RCA-18-22-003-1: Install Vibration Damper on Hydraulic Lines

Document Type	Customer Satisfaction Campaign Bulletin
Date	May 27, 2022
Affected Region(s)	USA
Affected Model(s)	R1T
Model Year(s)	2021
Approximate Build Dates	August 2021 - October 2021
 Refer to the FSA Dashboard to determine if this document applies to a specific vehicle.	
Vehicle System	18 - Suspension
Minimum Service Location	Service Center

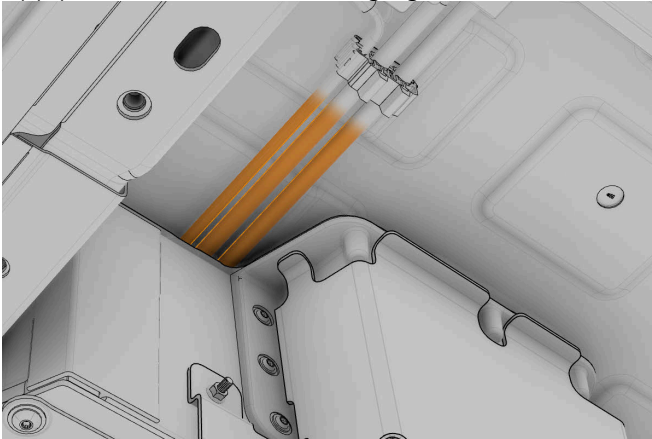
1. Remove: Panel, Underbody, HV Battery, Rear (refer to service manual procedure 606513010).
2. Inspect the hydraulic suspension lines for abrasion.

- If abrasion is present: Escalate for diagnostic assistance.
- If there is no abrasion: Continue to the next step.

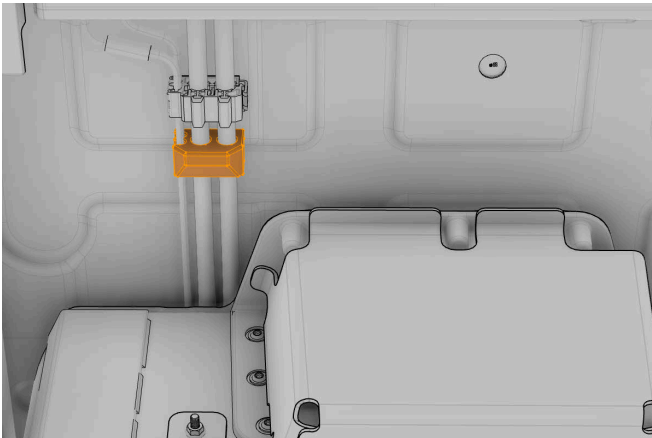
3. Apply silicone lubricant to the highlighted area.

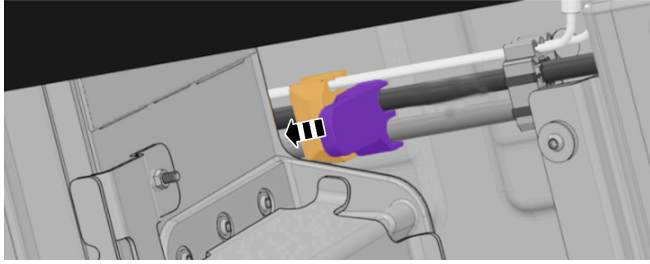
- a. Position the special tool so that the flat edge of the tool faces the rear of the vehicle.
- b. Use the special tool to push the vibration damper toward the front of the vehicle. Continue pushing the special tool until the tool contacts the HV battery.

**Tip:** If necessary: Tap the tool with a dead blow hammer to move the vibration damper.

**Note:** Shown with components removed for clarity.
